651S-1
GENERAL PURPOSE HF RECEIVER

PUB NO.	NOTE	DATE	SUBJECT
IB 1-72 ✓		03/01/72	Subassembly Interchangeability
SB 1		10/01/72	Reduction of 450-kHz Leakage From Synthesizer Reference Board All
SB 2		06/06/73	Reduction of Noise Level
SB 3		07/15/73	Add Keep-Alive Frequency Memory Function
SB 4		07/15/73	Extend Comma and Decimal Lamp Life in Frequency Display
SB A ✓		11/01/73	Change DCFE Filter Switching Diode
SB 5	1	12/15/74	Minimize TCU Circuit Card Response to Data Link Noise and Failure
SB 6	2	03/01/75	Reduce Intermodulation Level
SB 7		02/07/75	Reduce Internal Spurious Signals
SB 8		12/27/74	Allow Remote Control Operation With RS-232C Serial Control Interface Card A9
SB 9 ✓		02/15/75	Increase Life of Display Tubes
SB 10 ✓	2	12/31/75 Revised 08/02/76, 04/01/77	Replacing Display Tubes With LED Plug-in Assemblies
SB 11		Not issued	
SB B ✓		11/15/74	KAV
SB C ✓		01/15/78	Supply KAV Power to DCFE
SB 12 ✓		05/01/78 Revised 07/01/78	Replacing Nonprocurable Integrated Circuits

SERVICE BULLETIN A

SUBJECT: Change DCFE Filter Switching Diode

Figure 3

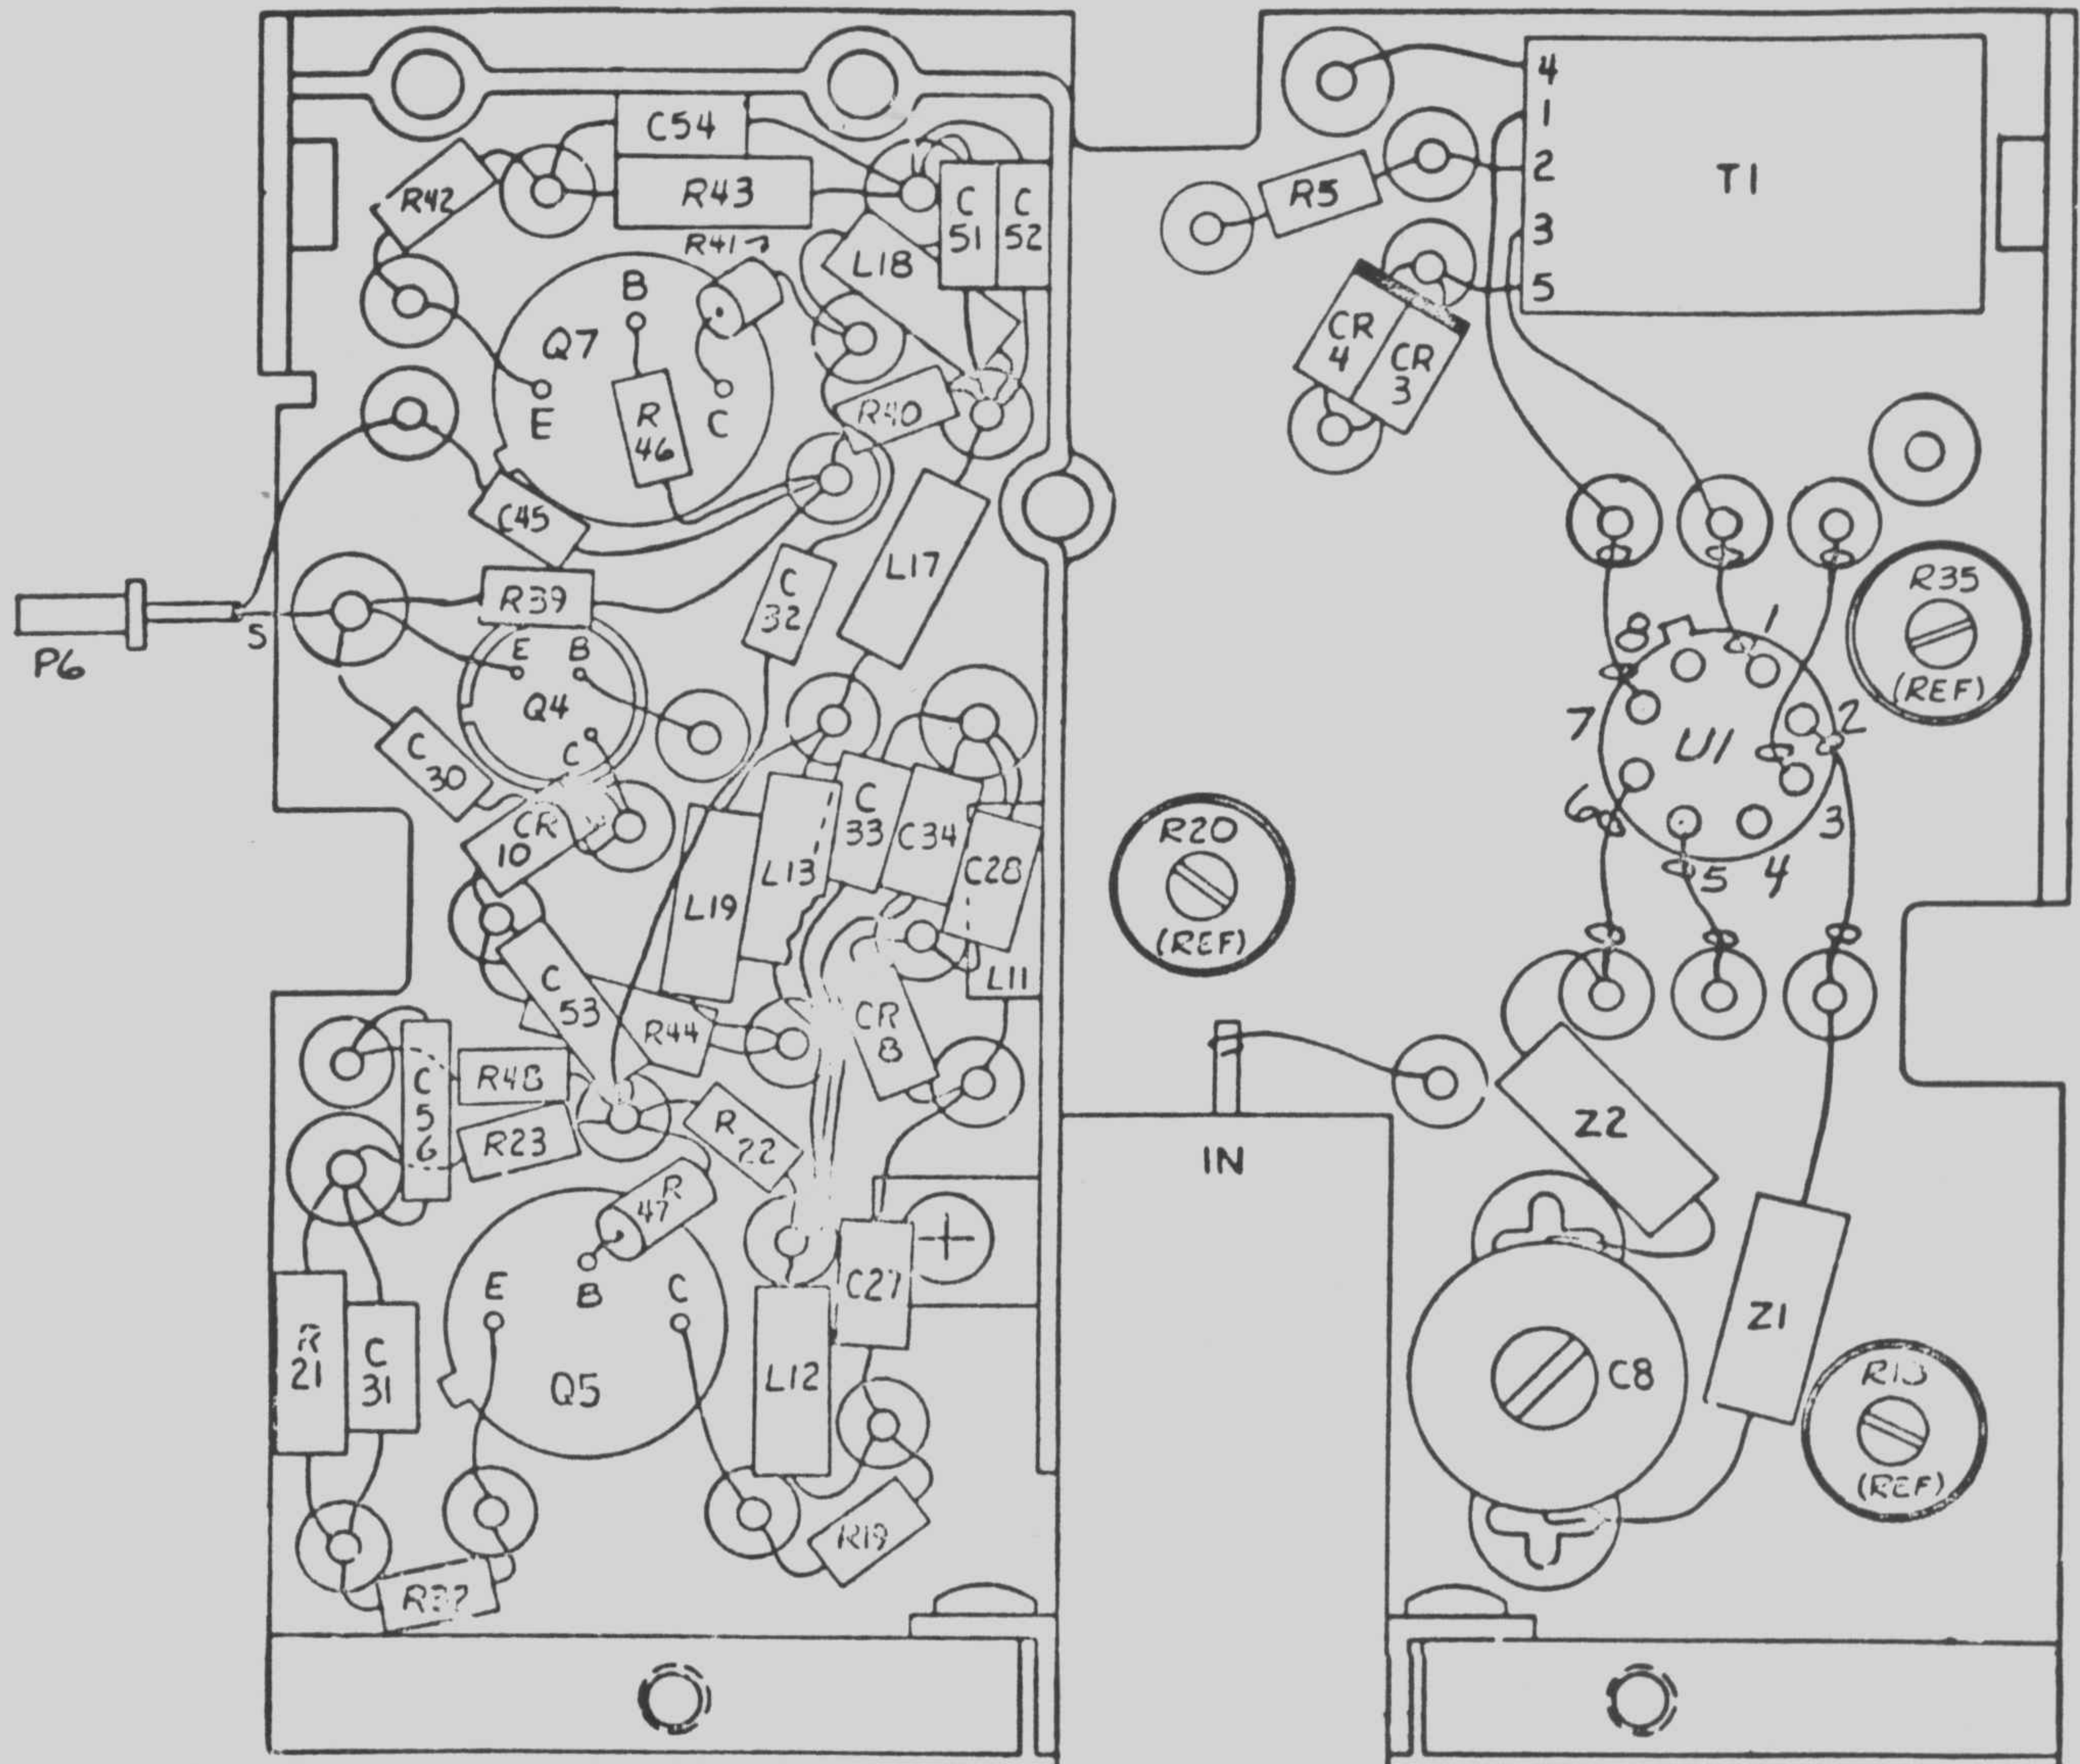
- L. Connect the new transistors as shown in figure 2.
- NOTE: Refer to figure 3 of this bulletin and the 651S-1/1A instruction book parts list while performing steps M through P. Refer to figure 4 for a schematic diagram which includes these changes.

- M. Remove mixer U1 (350-3080-020).
- N. Install new mixer U1 (351-0208-010) and connect as shown in figure 3.
- O. Remove capacitors C49 (37-6) and C50 (37-5).

- P. Remove capacitors C44 (37-141) and C46 (37-148) and replace them with 0.01 μ F capacitors (913-4240-100).
- Q. Locate rf mixer assembly part number 618-3258-001 and change it to 618-3258-002. Mark RWK REV T and RWK REV U near the part number.

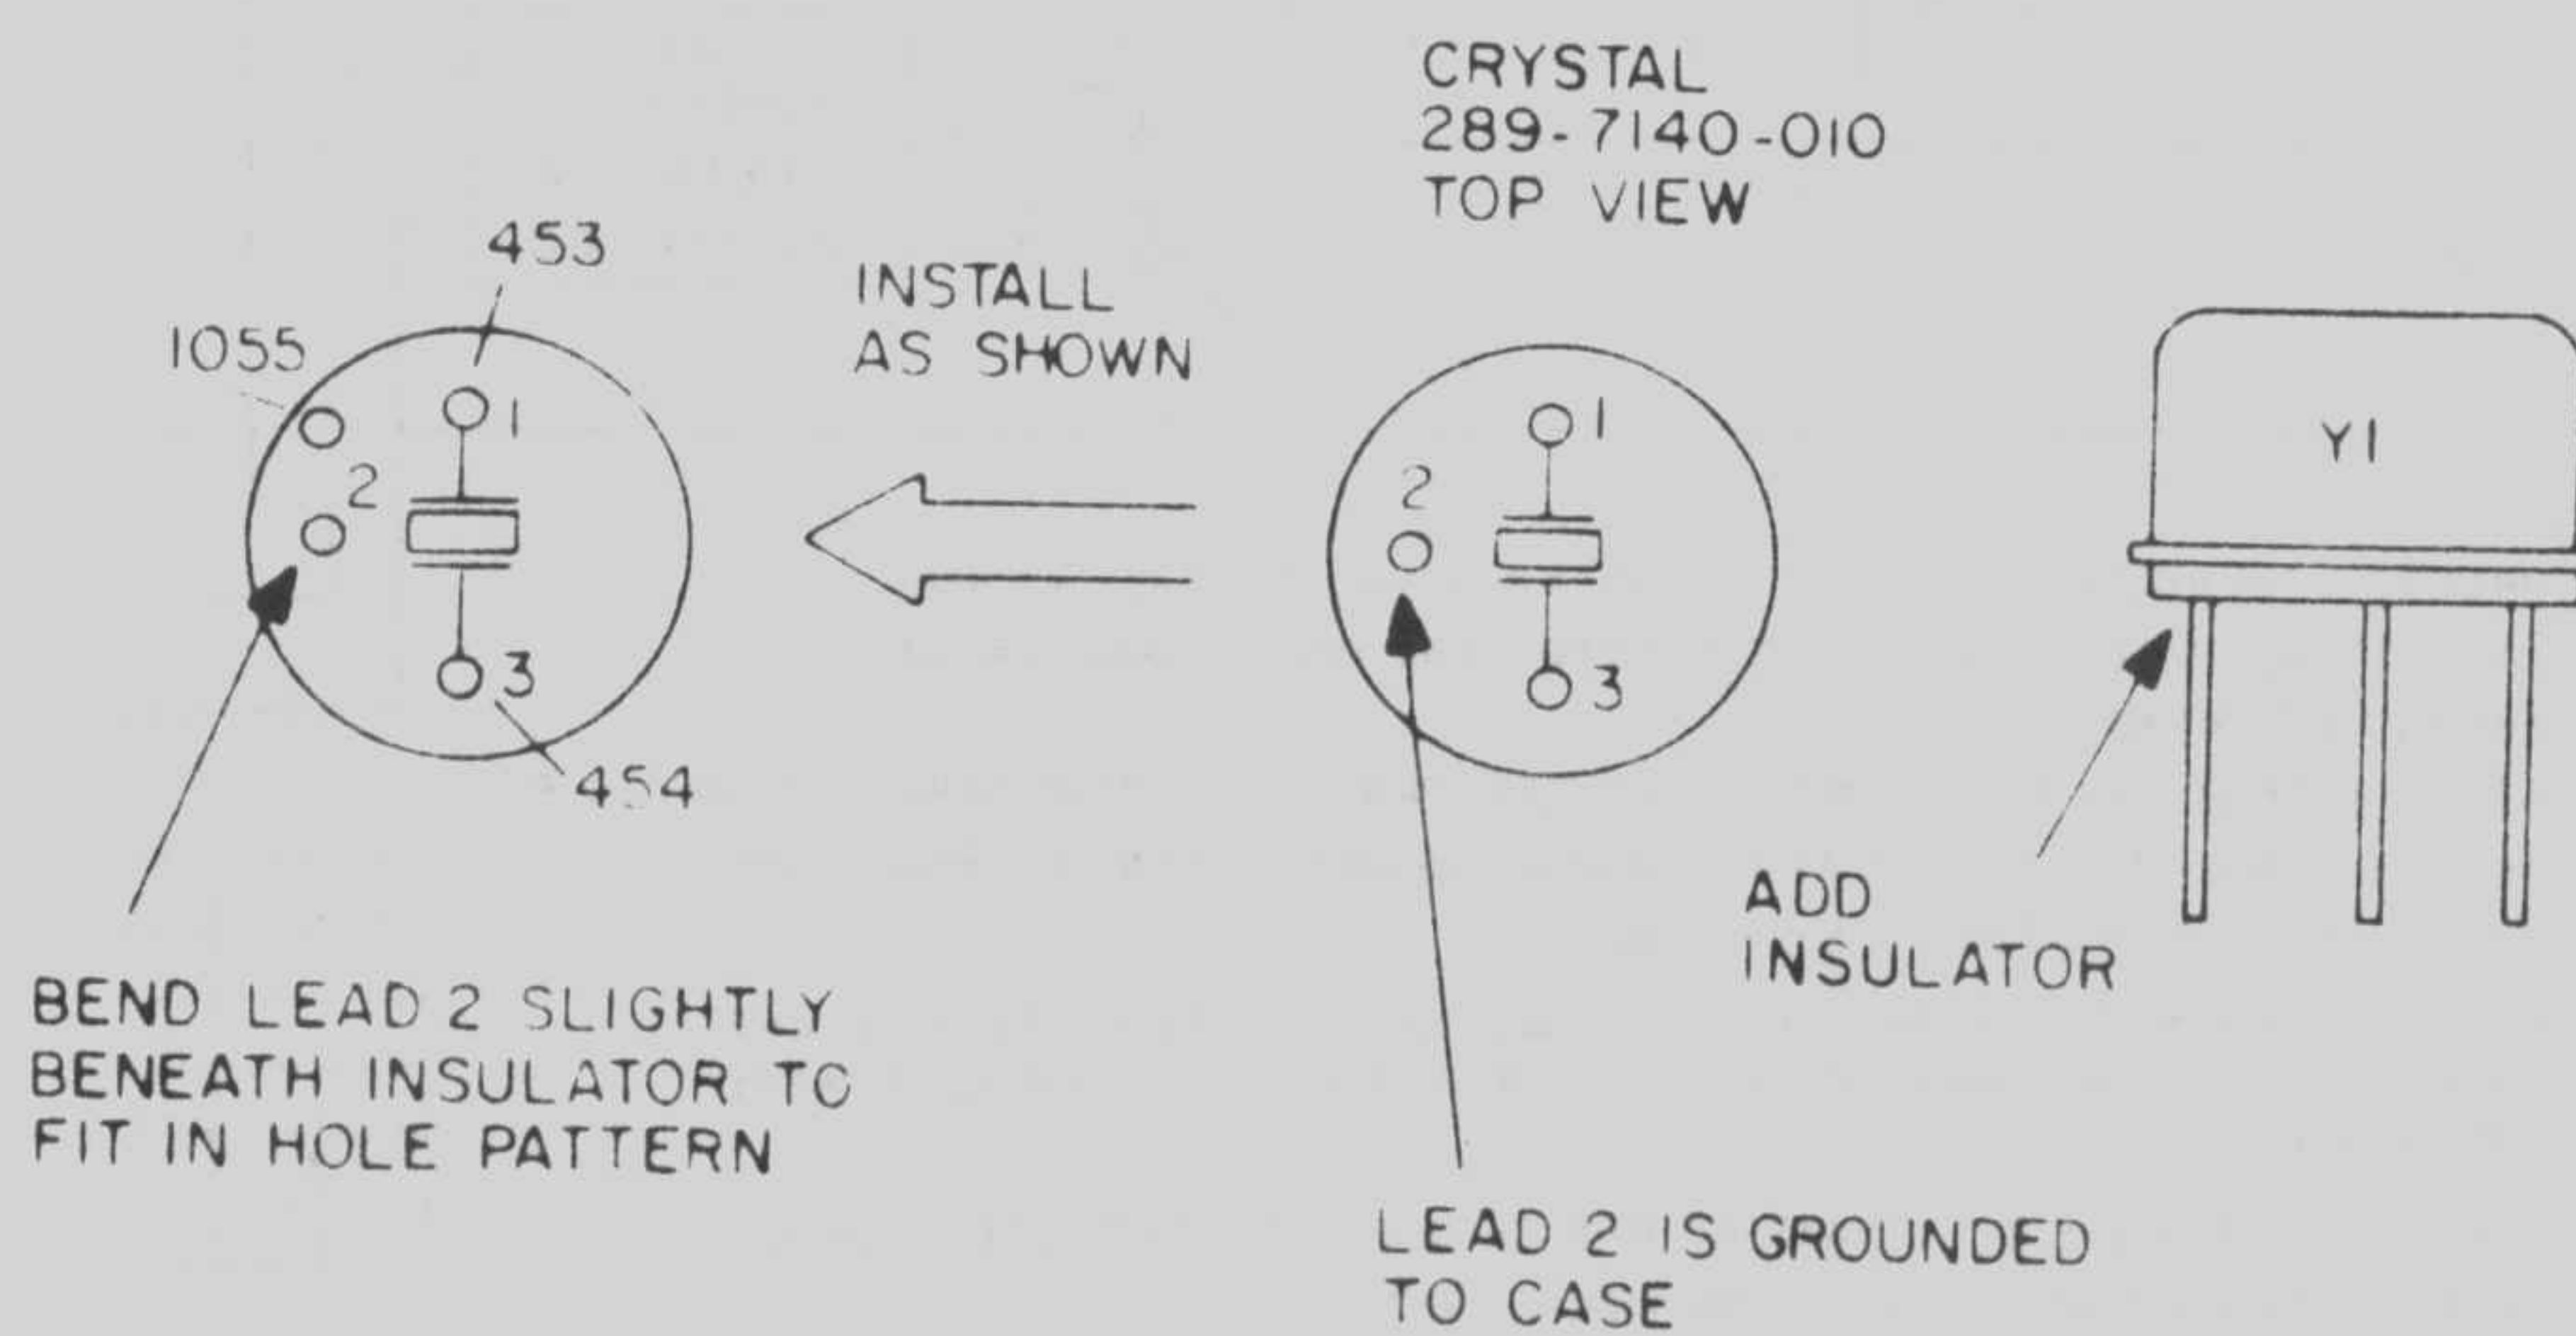
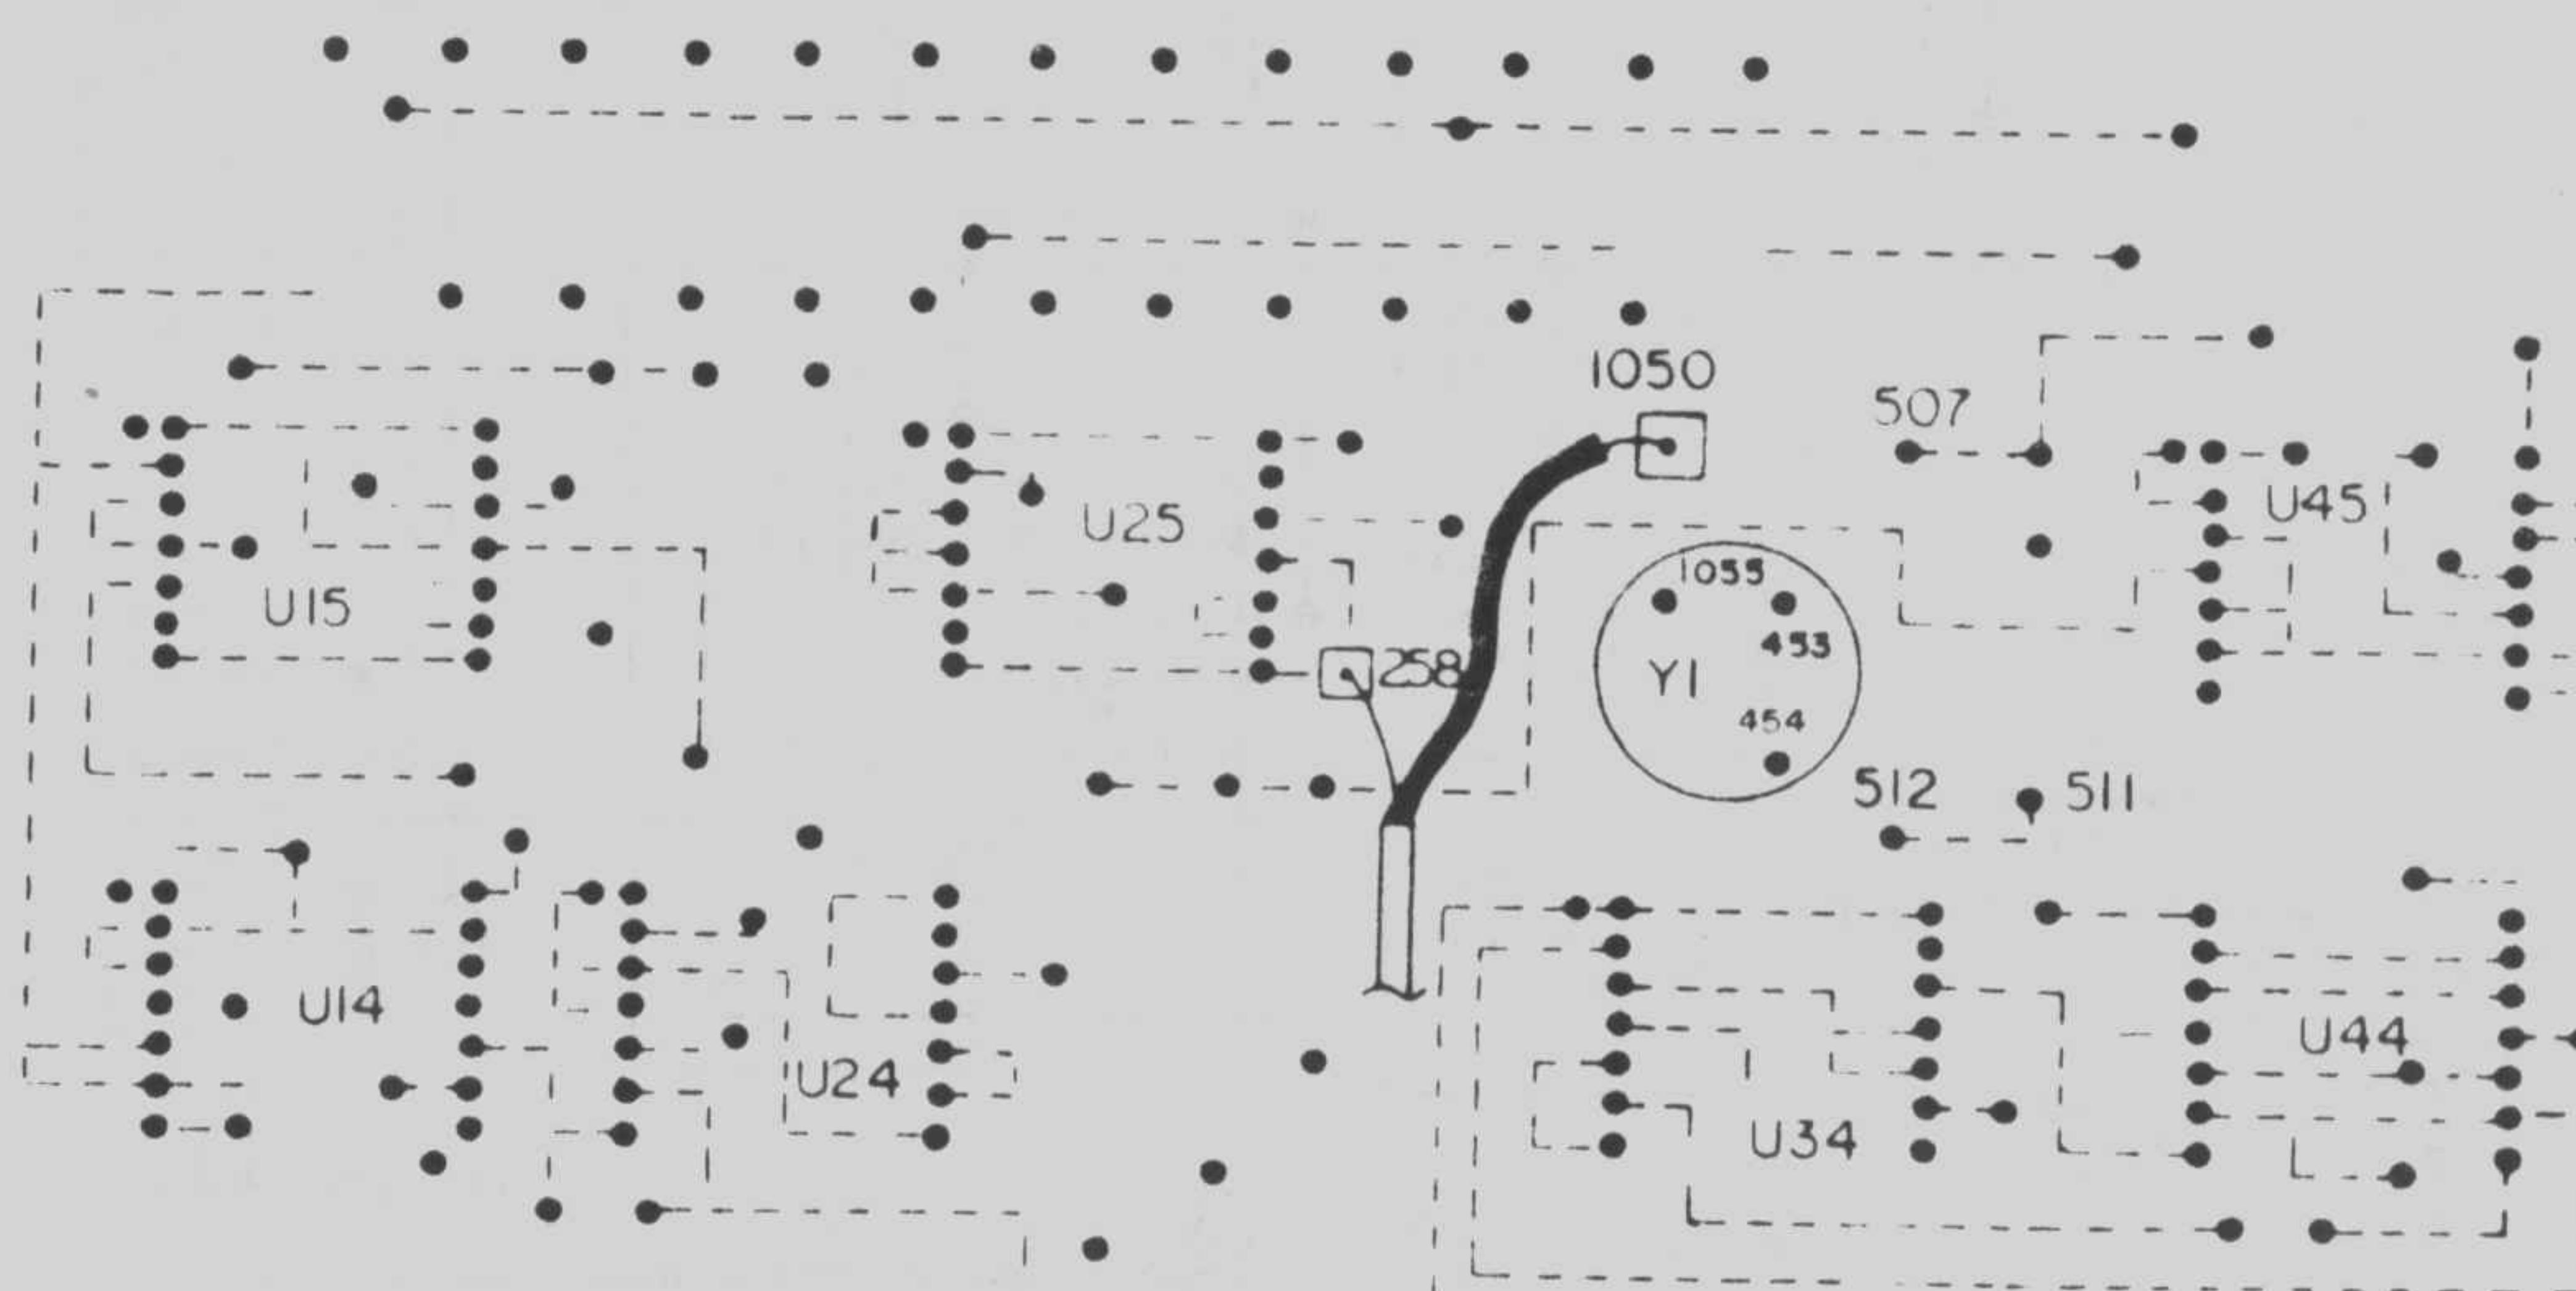
NOTE: Refer to figure 1 of this bulletin while performing steps F through I. Refer to figure 2 for before and after modification schematic diagrams.

- F. Unsolder and move the square pin and coax cable shield from hole 1055 to hole 258. Solder the pin in hole 258.
- G. Install 9.9-MHz crystal Y1 (289-7140-010) with insulator (352-9552-550) into holes 453, 454, and 1055 on top of board as shown in figure 1.
